ADDENDUM NO. 3

REYNOLDSBURG CITY SCHOOLS
L.F.O. ATHLETIC & ECO LAB PROJECTS

Date: **March 31, 2011**

Addendum No. 3 to the Drawings and Project Manual, dated **March 17, 2011**, for **L.F.O. ATHLETIC & ECO LAB PROJECTS**, Reynoldsburg City Schools, 7244 East Main Street, Reynoldsburg, Ohio 43068; as prepared by Moody Nolan, Inc., 300 Spruce St. Suite 300, Columbus, OH 43215.

PIPE GATE DETAIL

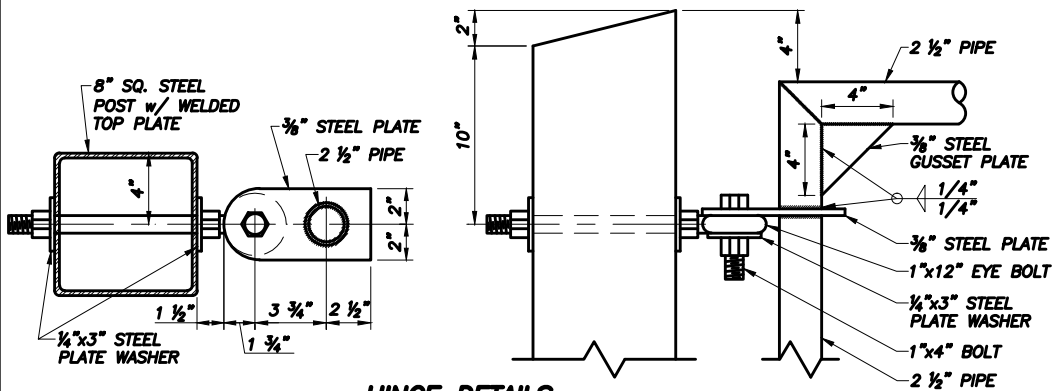
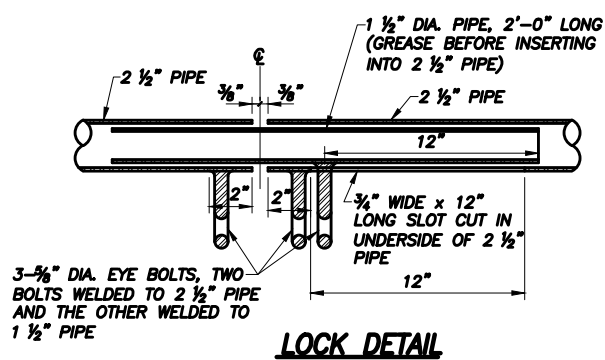
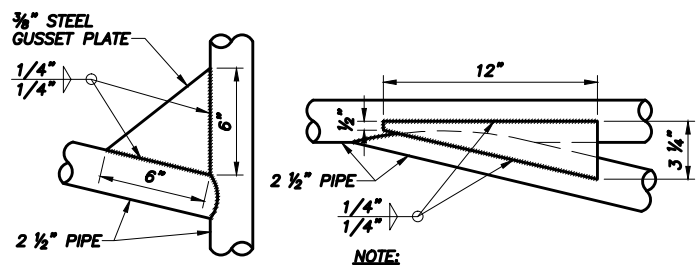
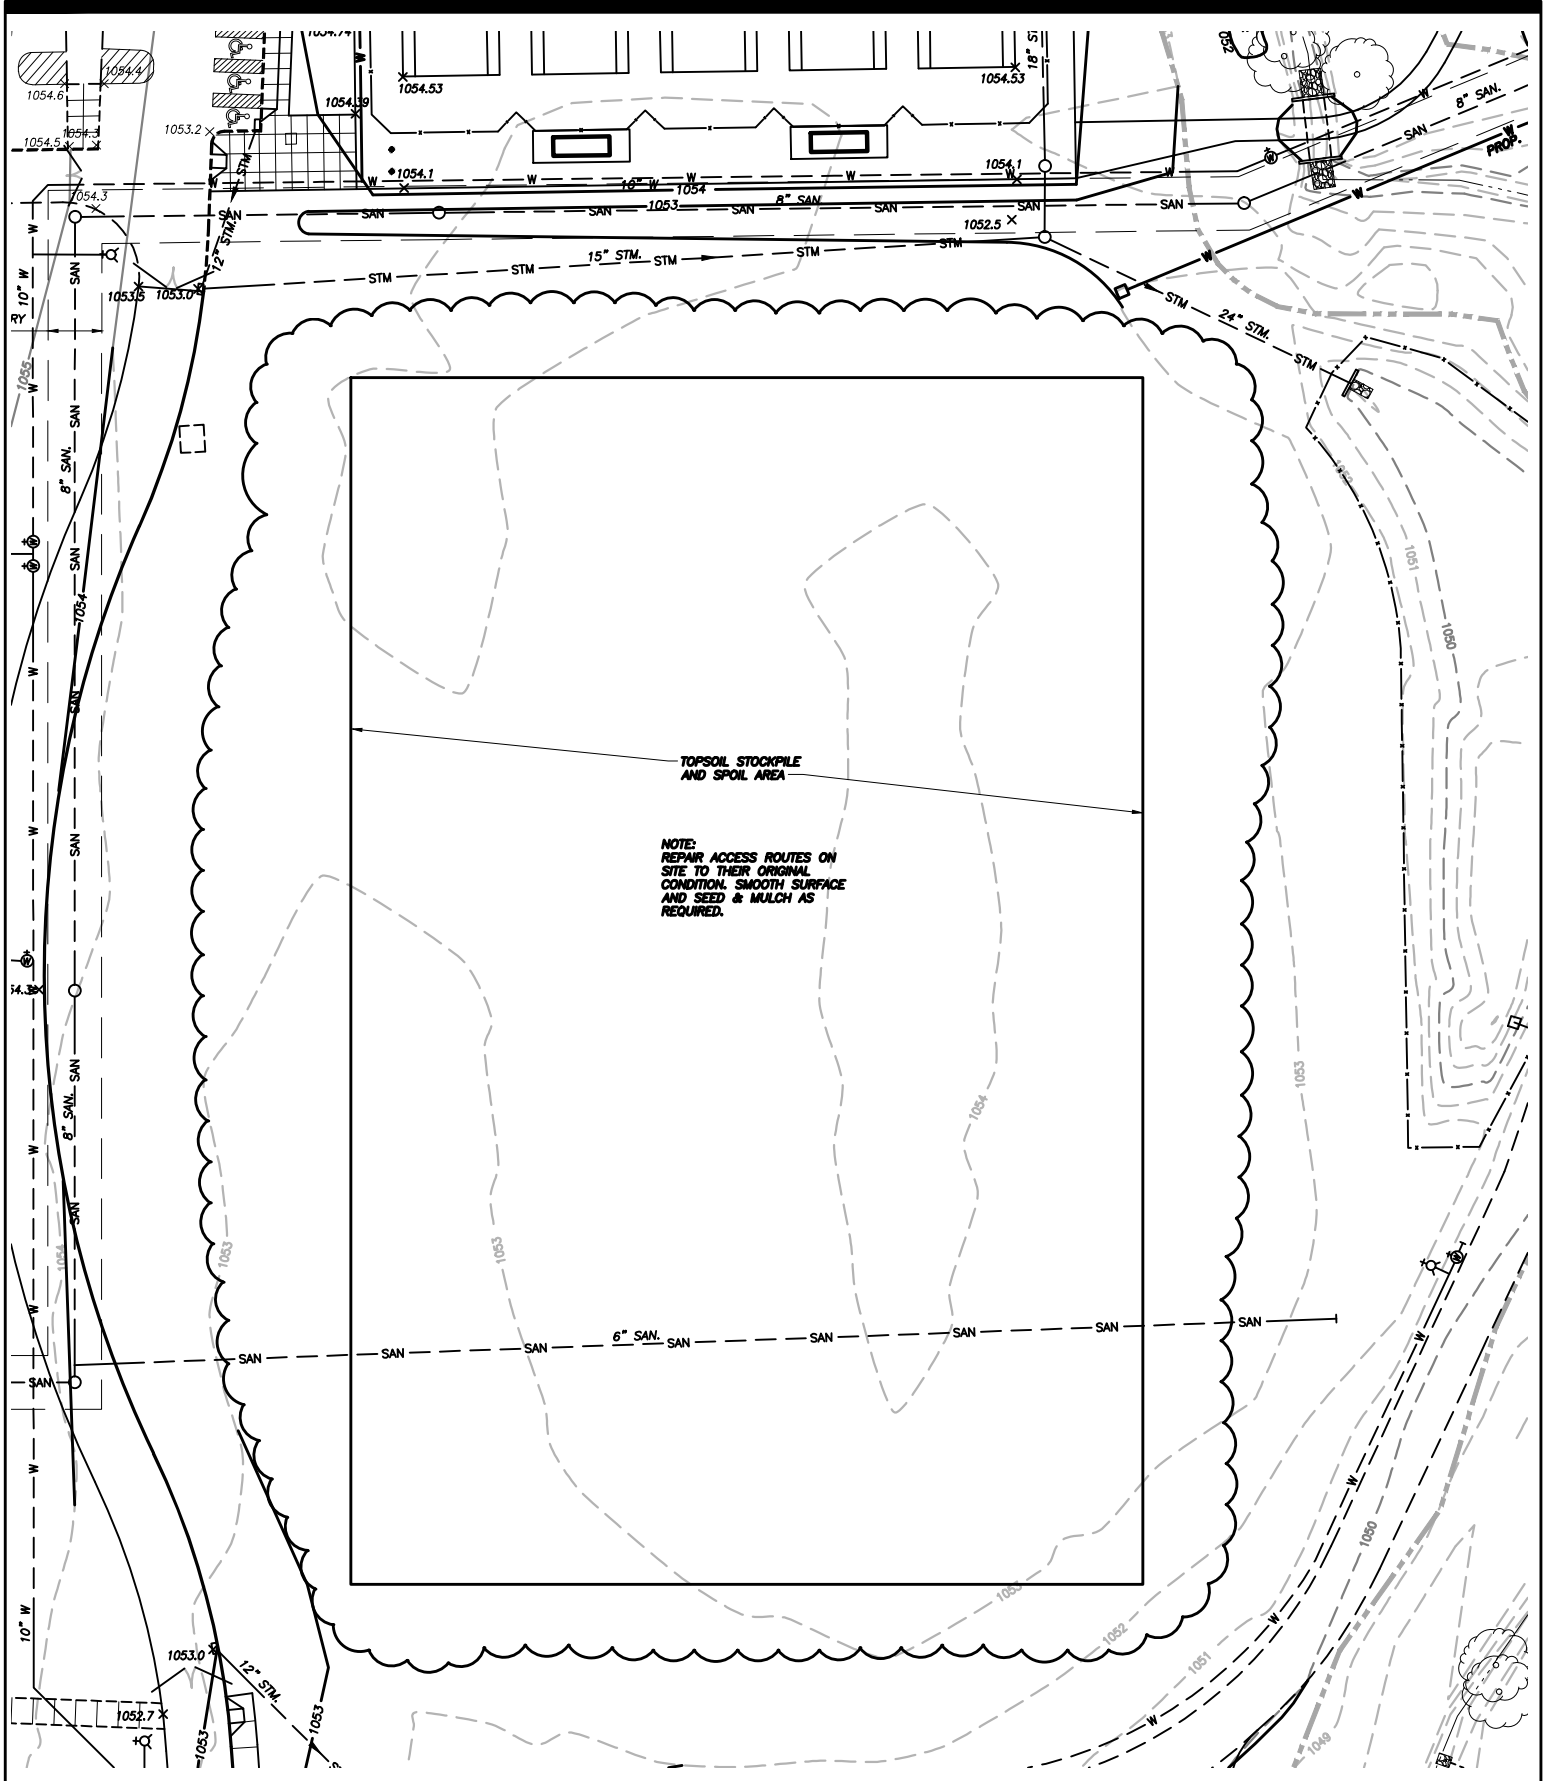
- Item 2-16 Drawing Cs4.1
a. **ADD** Pipe Gate Detail, see sketch C-SK14.
b. **REVISE** Detail 7 Quick Coupler Detail, see sketch C-SK16.

1. GATE POSTS SHALL BE LOCATED PER PLAN
2. ALL PIPE SHALL BE SCHEDULE 40 GALVANIZED STEEL
3. ASSEMBLED GATE PANELS SHALL BE HOT-DIP GALVANIZED PRIOR TO INSTALLATION
4. ALL HARDWARE SHALL BE GALVANIZED
5. PADLOCK TO BE PROVIDED BY OWNER
6. REFLECTORS TO BE PROVIDED BY OWNER AND INSTALLED ON PIPE GATES BY CONTRACTOR (2 PER GATE PANEL)

C-SK15

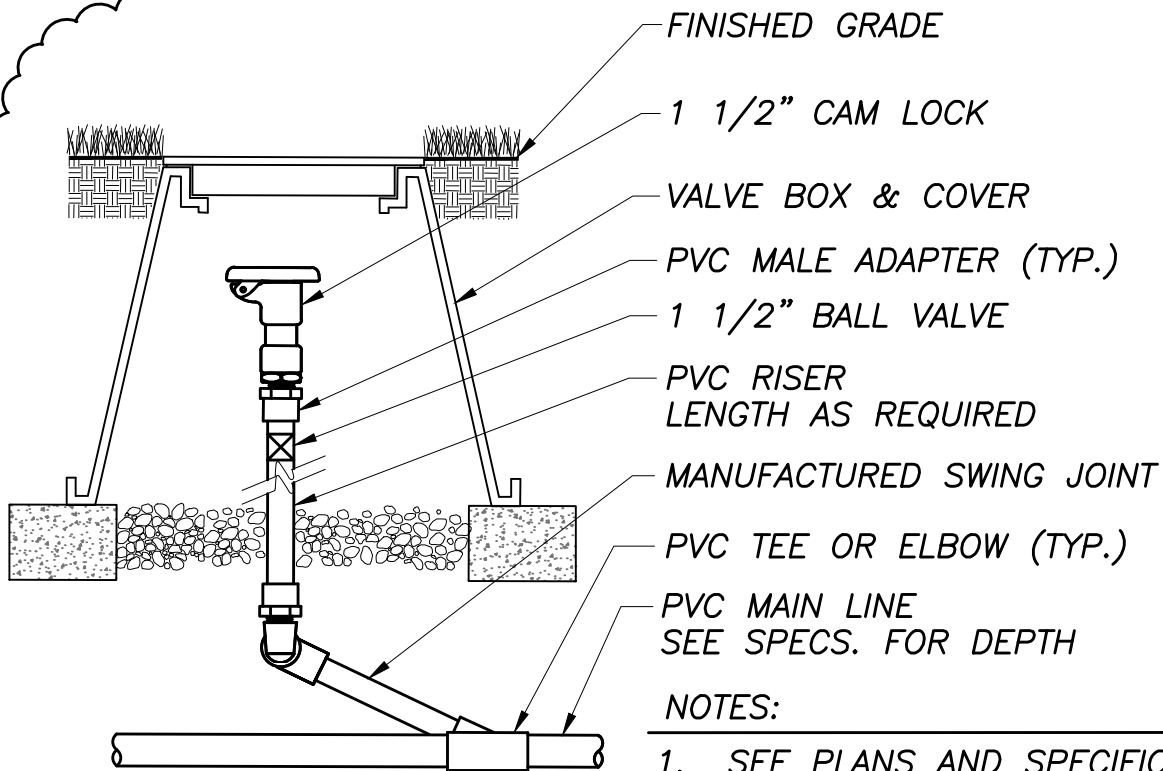
- Item 2-13 Drawing Cs2.1
REISSUE sheet.
- Item 2-14 Drawing Cs2.1
Coded note 3
DELETE "Rated for 40 to 50 GPM @"
ADD "See specifications for pump sizing"
- Item 2-15 Drawing Cs2.2
ADD riparian vernal pool, see sketch C-SK12.
ADD topsoil stockpile and spoil area, see sketch C-SK15.
